AMENDMENTS TO THE DRAWINGS

REMARKS

Drawing Objections

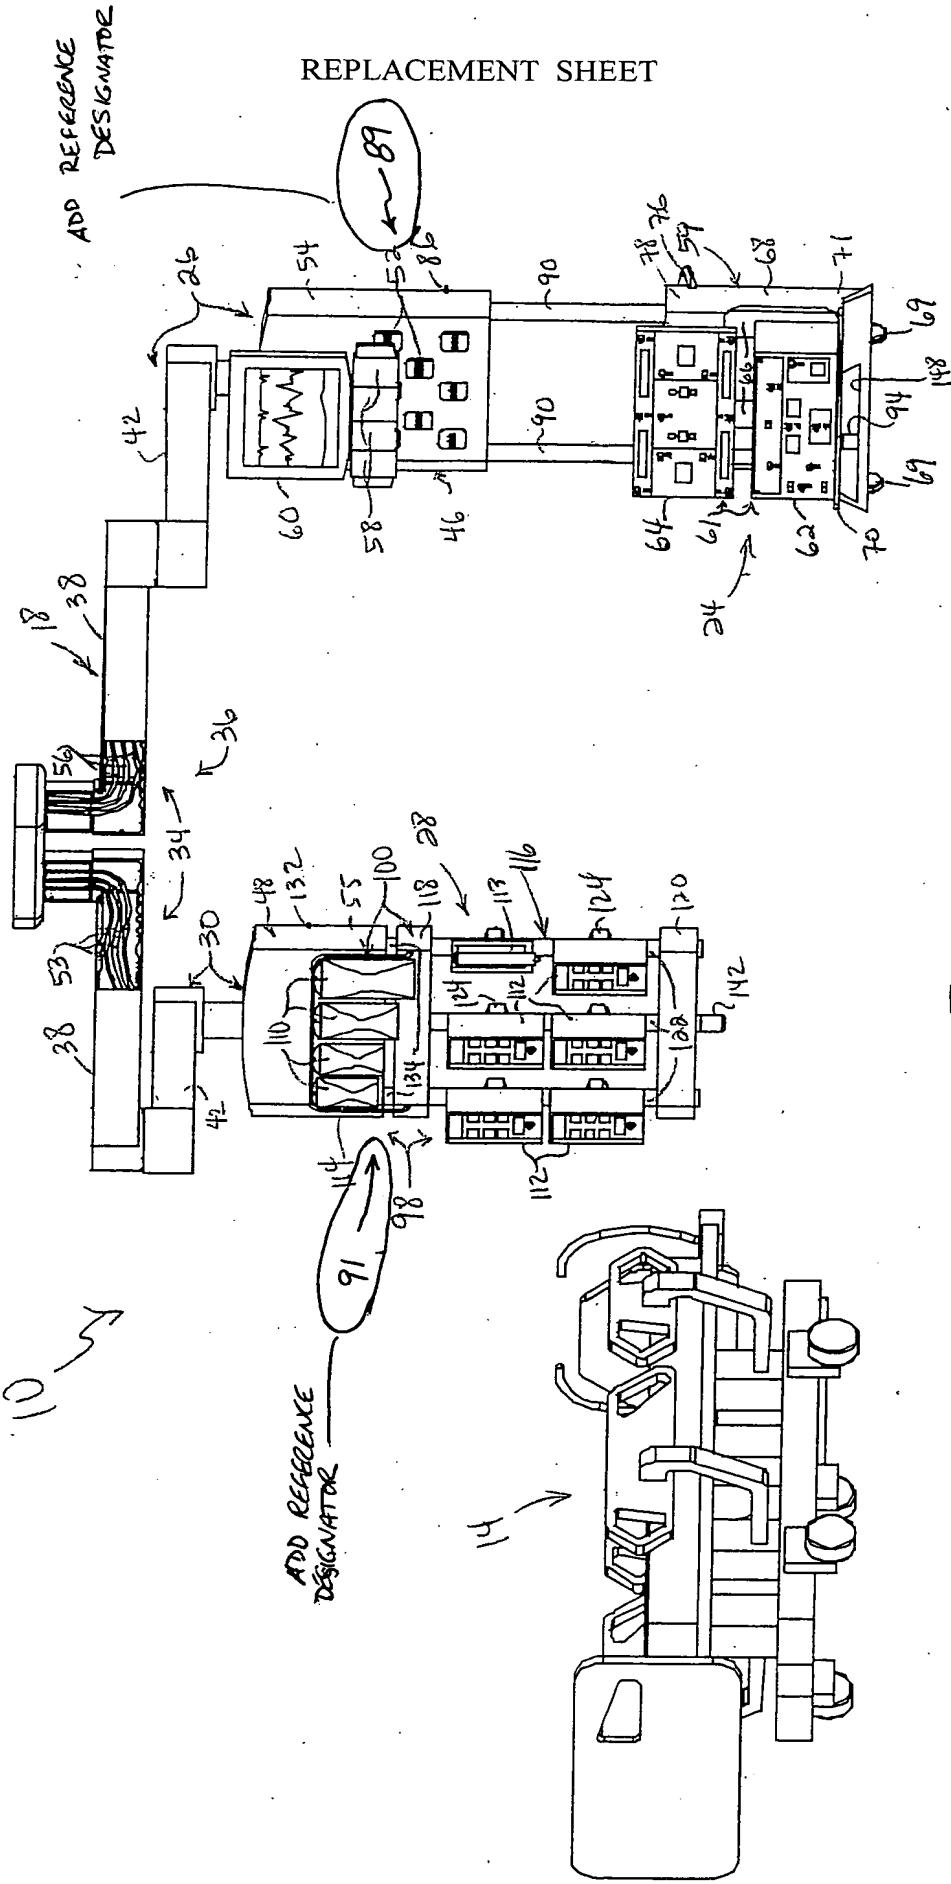
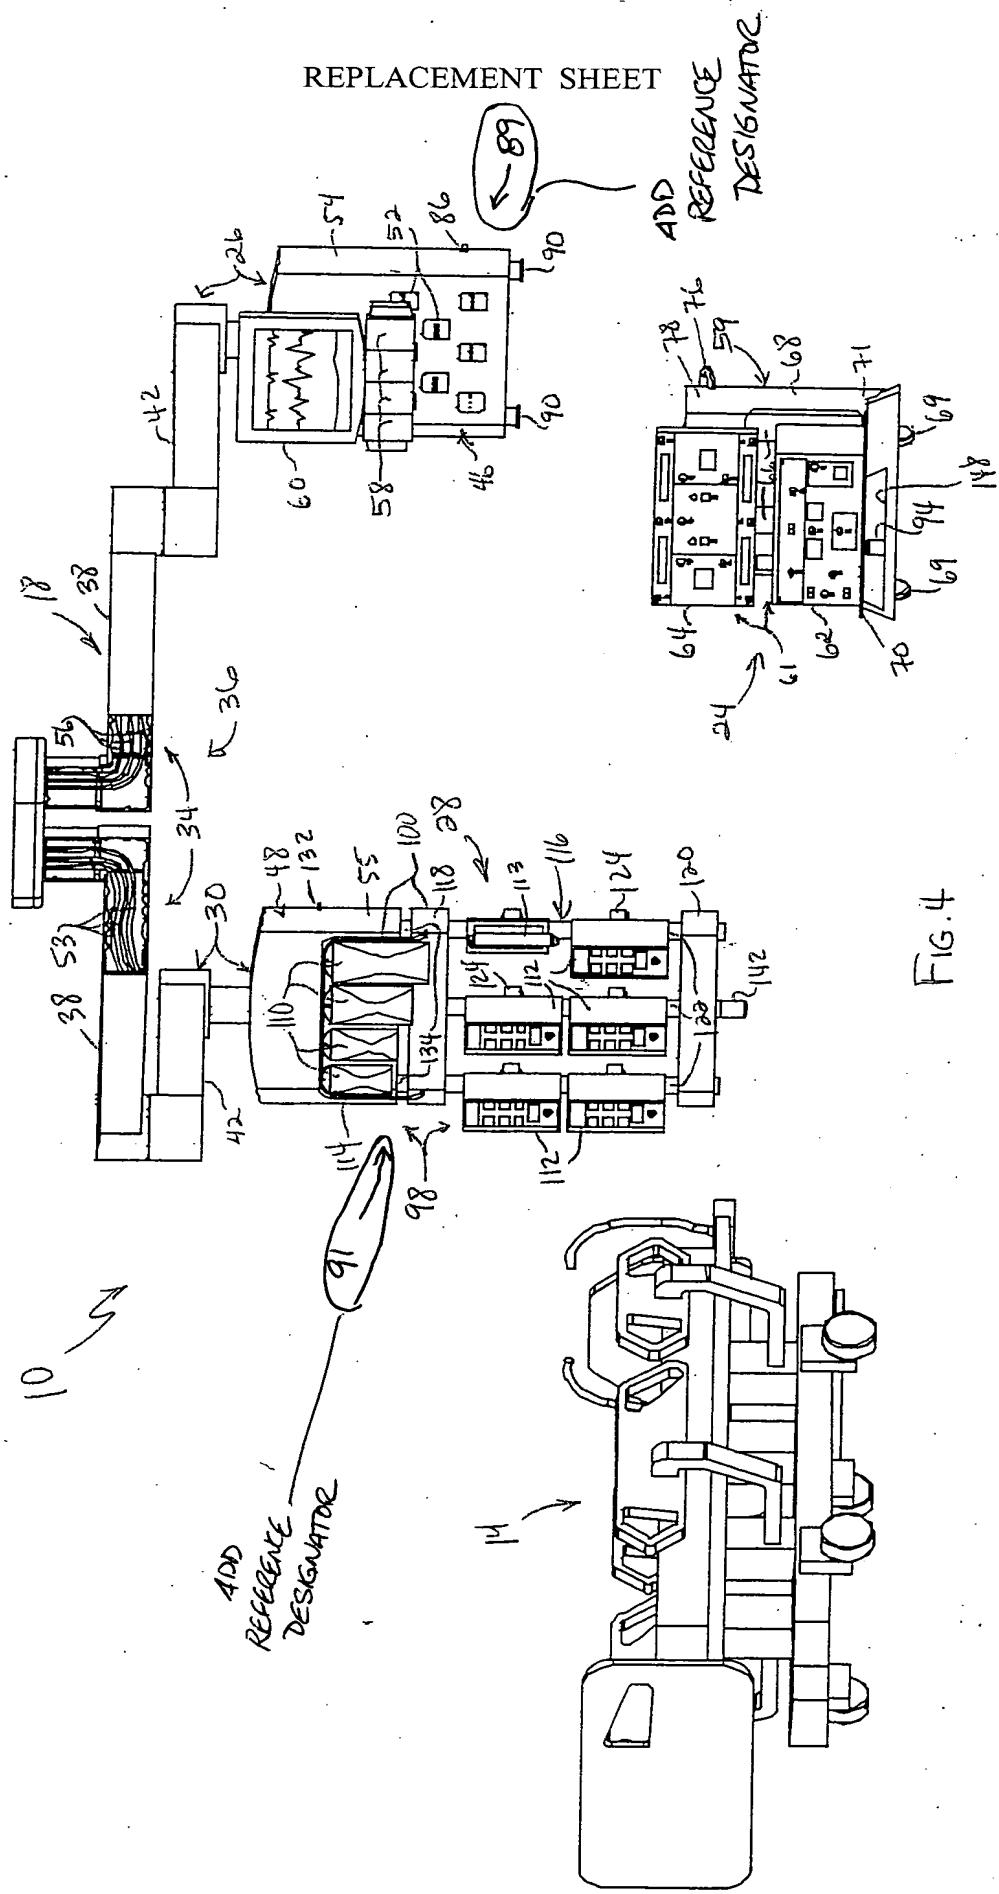
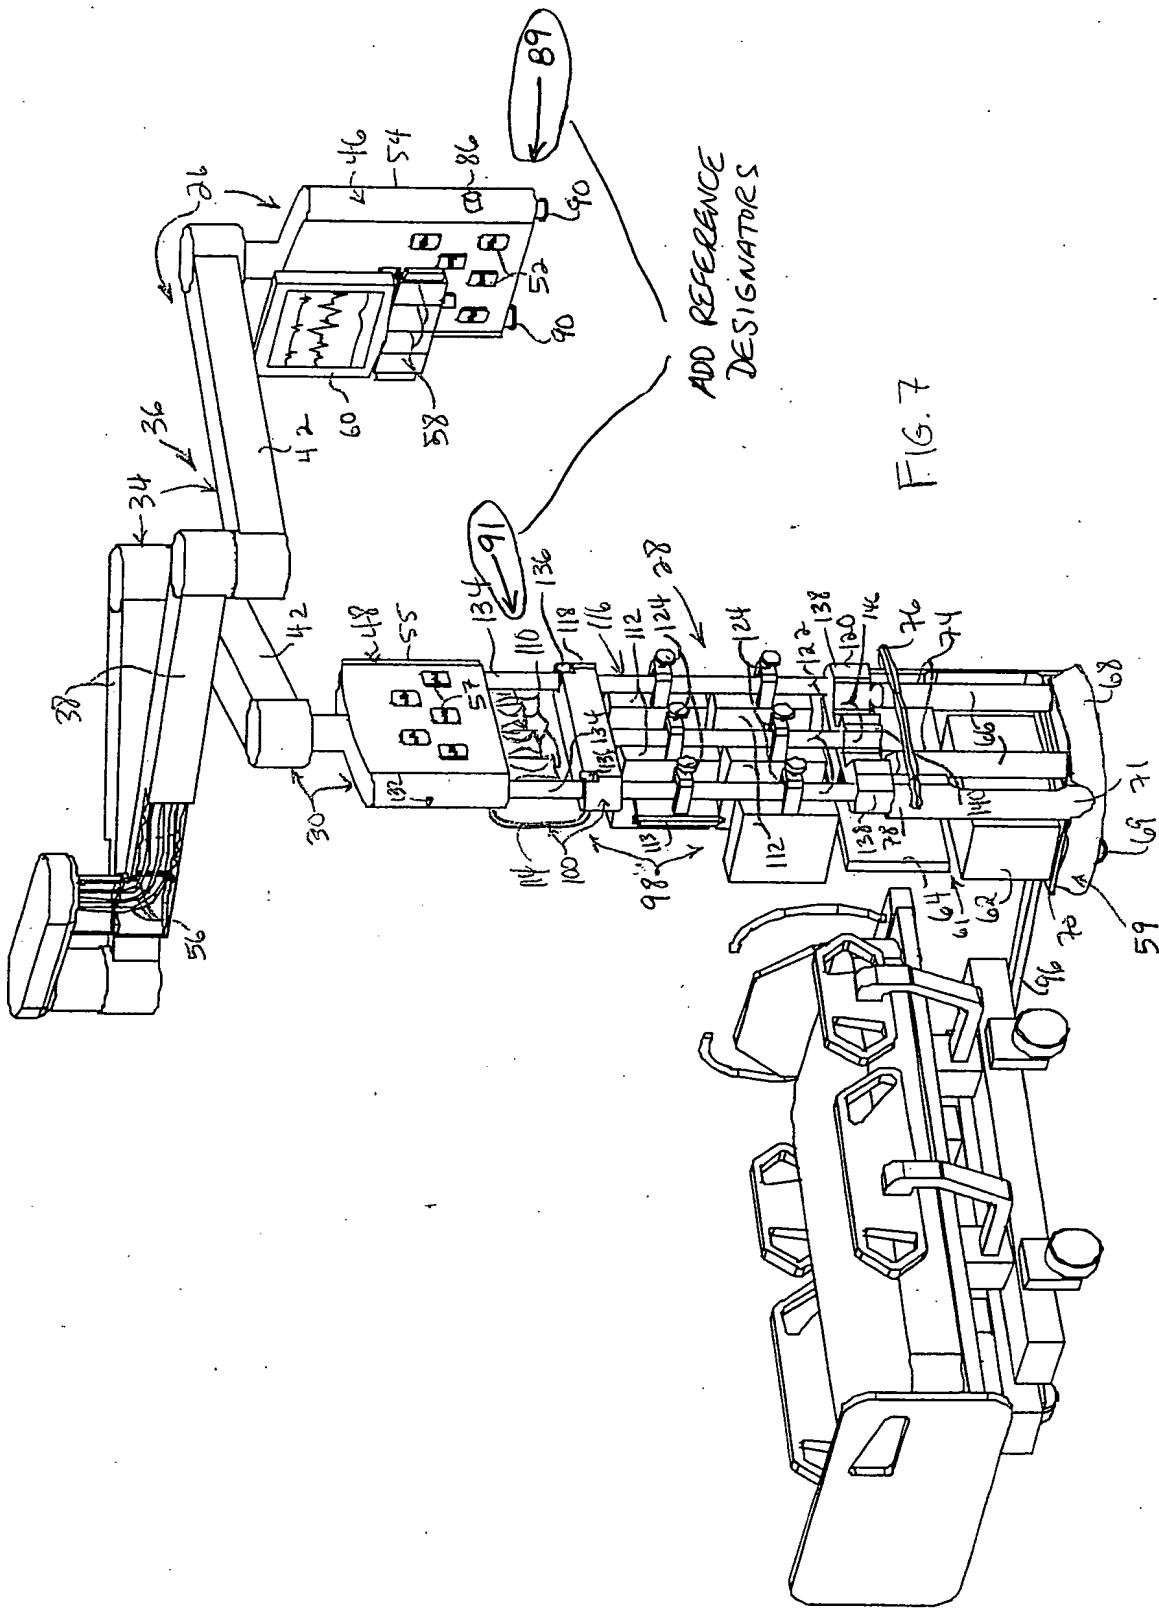
The Examiner has objected to the drawings under 35 CFR 1.83(a) for failing to show every feature of the claimed invention, namely the lifters. The lifter(s) claimed comprise multiple components shown in the figures and described in the specification. For example, “[t]he first lifter has a pair of vertically extending arms 90 (see Figs. 3-4) operable to extend and retract from housing 54 in response to operation of the first driver.” (paragraph 00038 of the Application). Also, “[t]he second lifter also has a pair of vertically extending arms 134 (see Figs. 7-8) operable to extend and retract from housing 55 in response to operation of the driver.” (paragraph 00044 of the Application.) To clarify that the lifters are illustrated in the drawings as filed, the specification and drawings have been amended to include references 89 and 91 for the first and second lifters respectively. The Applicant respectfully submits that the lifter feature is therefore adequately illustrated in the drawings as filed and one skilled in the art would understand the operation of the lifter as disclosed in the specification with reference to the drawings as filed. No new matter has been added. Thus, the objection to the drawings is believed to be overcome.

Please replace existing figures 3-4 and 7-8 with the replacement drawings attached. The figures have been amended to include reference numbers 89 and 91. Reference numbers 89 and 91 have been added by the amendments to the specification to the preexisting descriptions of the first and second lifters, respectively. No new matter has been added.
